NRL Report No. B-1365

Report of Test

Twin Buzzer

Bendix Marine Products Company

Plate 1

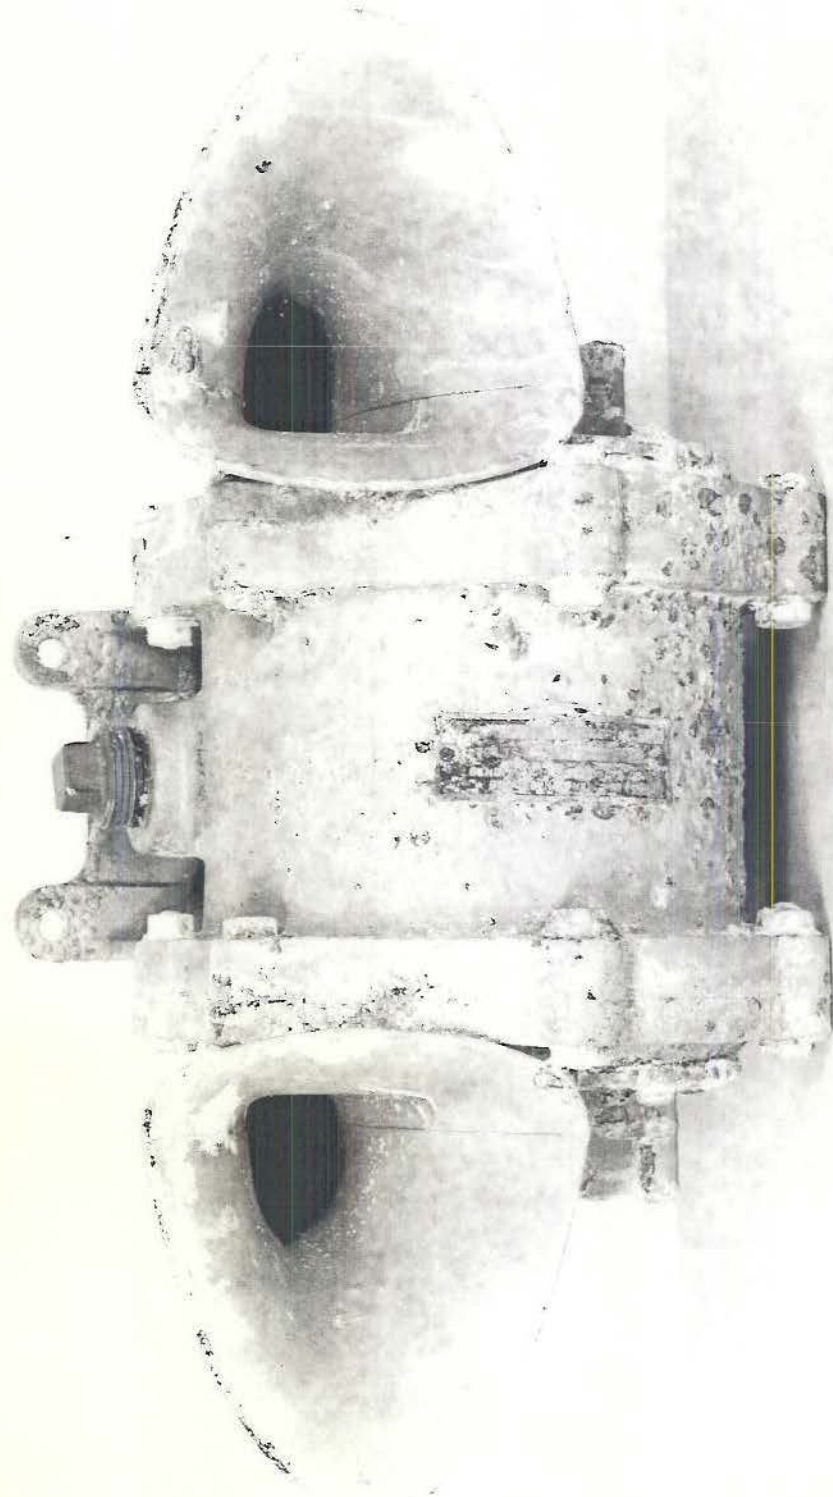
(a) This twin buzzer, manufactured and submitted by Bendix Marine Products Company, Brooklyn, New York, is not covered by the specifications, reference (b). However, it did comply with the greater portion of the specifications, namely, endurance, shock integrity, temperature rise, operation at over and under rated voltage, and watertight integrity requirements. In addition, there was no great damage to the unit at the close of the salt spray test, as shown by photographs, Plates 1 to 3 respectively, but the die-cast alloy was attacked and the paint was considerably deteriorated.

25. This twin buzzer, manufactured and submitted by Bendix Marine Products Company, Brooklyn, New York, is not covered by the specifications, reference (b). However, it did comply with the greater portion of the specifications, namely, endurance, shock integrity, temperature rise, operation at over and under rated voltage, and watertight integrity requirements. In addition, there was no great damage to the unit at the close of the salt spray test, as shown by photographs, Plates 1 to 3 respectively, but the die-cast alloy was attacked and the paint was considerably deteriorated.
